February 16, 2012

Impacts of Draft 2012 International Fire Code on Residential Solar PV Installations in Washington State

Prepared
by
Jeff Randall
, Power Trip Energy, Corp

Example 9: The shop/guest house on the left is the only home in our 260 installations where we have covered both side of a roof with solar modules.

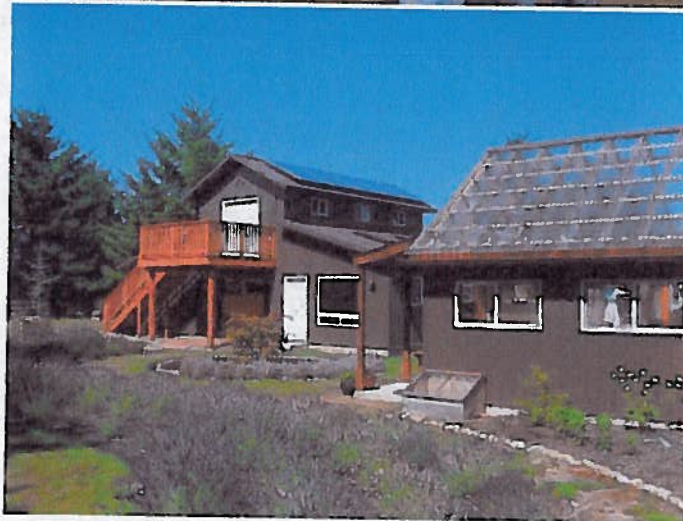
Is this situation hazardous? The ceiling is vaulted and there are multiple windows and doors for ventilation. Would a firefighter ever need to go on the roof?
